BIA Supplementary Information

L24/055/02

154 Royal College Street,

Preface

Proposed Basement Floor
Scale 1:100

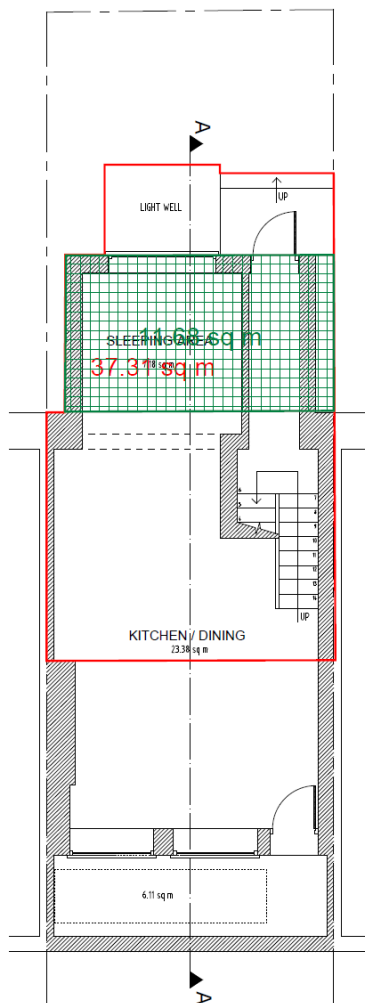
Query 5 – Surface Water Proposals

Further to previous correspondence it is understood and agreed that the increase in surface water runoff will be minimal (please see calculations below). As discussed, levels of attenuation will be dependent on the agreed connection flow rate with the local water authority, however the inclusion of SuDS features can limit this requirement notably. Any attenuation crates etc. will be proportionate to the minor increase and can be positioned to the rear of the plot without detriment to the adjacent structures or underlying hydrology.

Approximate increase in surface area to the rear catchment of the property is 30%

On that basis, where greenfield run-off rates are unfeasibly low for such a small catchment area, the proposed run-off rate during the 1 in 100yr + 40% climate change would need to be set at: 0.75 l/s

Due to the small orifice plate required, upstream source control will be required in the form of SuDS. The proposals could include a small attenuation tank, bio-retention plants/pods on the rainwater downpipes, and silt traps ahead of the flow controls.

Figure 2.1 Borehole logs from 152 and 156 Royal College Street (looking north-eastwards)

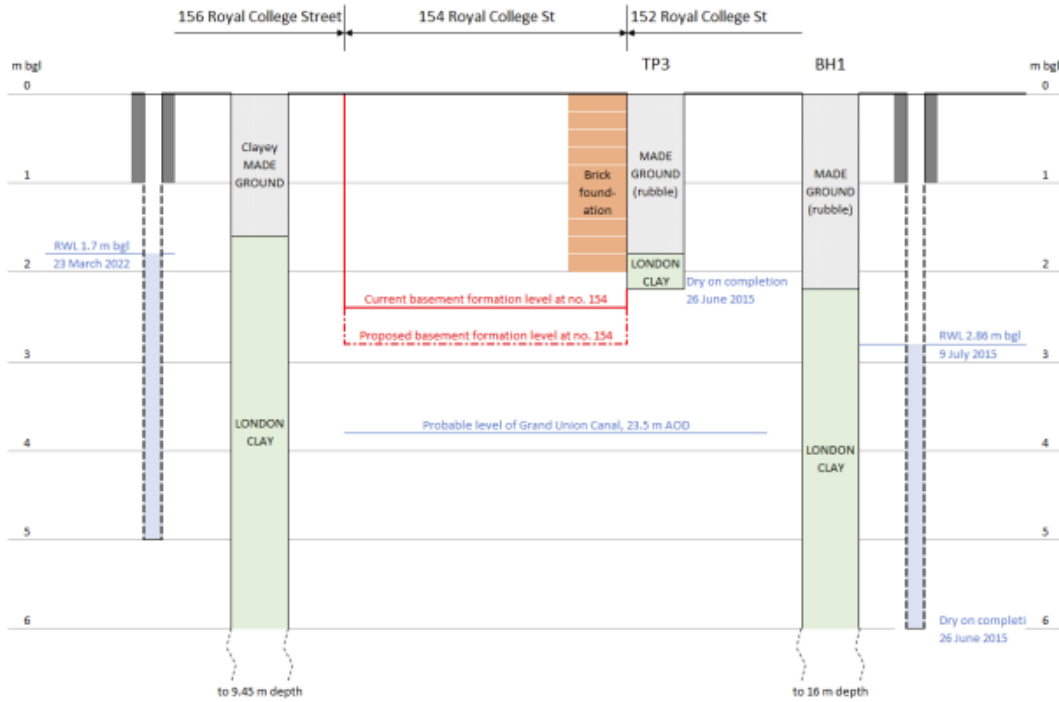
Query 6 – Geotechnical Parameters

It would appear that the made ground to No.152 is associated/ indicative of the historic demolition of the previous basement/ building, as such it would be prudent to presume that the properties of the soils to No.154 are in keeping with the prevailing conditions documented for No.156 and at depth for No.152 underlying the rubble layer.

The following geotechnical parameters are therefore expected/ advised.

Depth	Stratum	Effective Angle of Friction	Effective Cohesion (c')	Bulk Unit Density (kN/m ³)
0.00 - 1.80m	Made Ground	Conservatively 25°	0 kN/m ²	20 kN/m ³
1.80m - 9.45m +	London Clay	Typically, 20°	0 kN/m ² ; 5kN/m ² After 5.0m	20 kN/m ³

Vertical Movement (within acceptable tolerances)

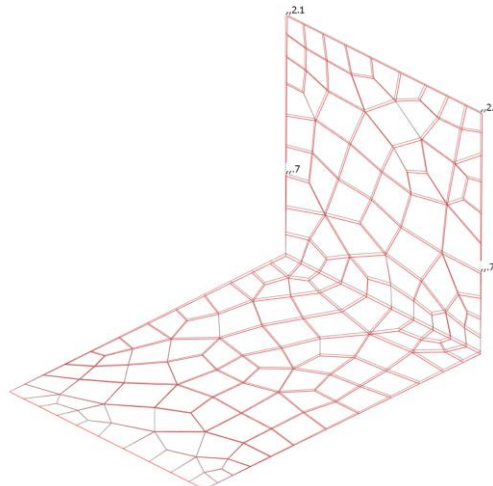
Query 8 & 9 – Anticipated Structural Movement/ Damage Categorisation

Preliminary analysis of a typical 300mm thick slab/ wall construction using soils parameters outlined in query 6 has been carried out to examine wall displacement/settlements. It should be noted that this construction is to extend into the London Clay stratum underlying the site as such design values have been selected accordingly.

Based on general procedures for Stage 2 Damage Category Assessments outlined in section 6.3 of CIRIA C760 an effective horizontal tensile strain of approximately 0.05% is anticipated. As such the shorter underpin to the main property is likely to result in Damage Category 1 – Very slight in keeping with point 4.33 of Camden Planning Guidance: Basements (2021).

Influence on Horizontal strain on $\Delta/L/\epsilon_{lim}$

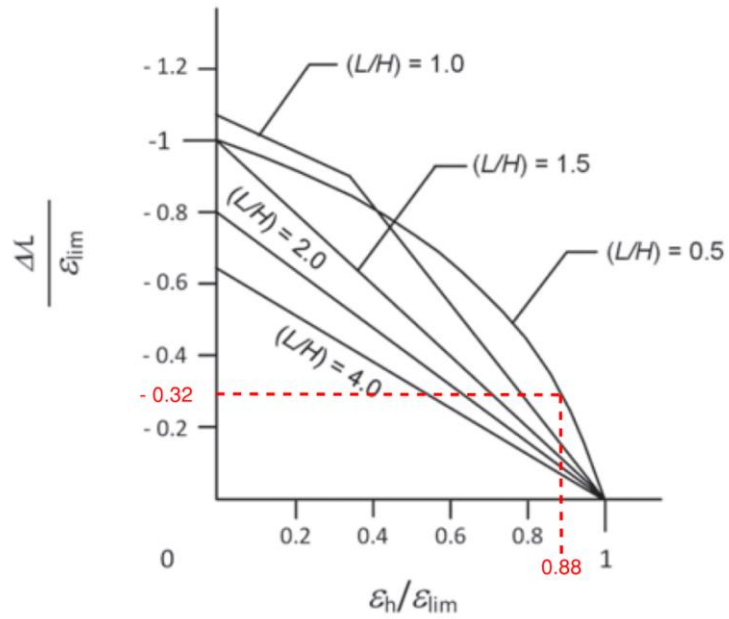
9	Stability	Further justification required to support building damage conclusions. - Current assessment indicates up to Category 2 damage – this is not allowable under CPG Basements – open. - Current assessment is not considered conservative; a minimum of 5mm vertical / horizontal movement per stage of underpinning would be anticipated in dry, stable conditions. Its noted that underpinning through Made Ground with perched water is likely with dewatering to be implemented, which may further impact movements / damage category – open.	Open – See 4.18

From analysis the following settlement graph demonstrates the anticipated soil movements within a 5.0m susceptible zone to the excavation/basement construction relative to each party wall line. Given that 154 is a mid-terrace property with similar construction present each side, similar movements would therefore be anticipated to each side.

Adjacent Property	152 Royal College Street	156 Royal College Street
Building Width – L (m)	5.00	5.00
Building Height – H (m)	10.50	10.50
L/H = 0.476	0.50	0.50
Max Deflection	0.012	0.012
ΔL (%)	0.024	0.024
ϵ_{lim}	0.075	0.075
$\Delta/L/\epsilon_{lim}$	0.32	0.32
Length to Negligible Horizontal Movement (4x)	4	4
δh_{max} (m)	0.004	0.004
δh (m)	0.0021	0.0021
$\Delta h/L$ (%) = ϵh	0.10	0.10
Damage Category	<1	<1
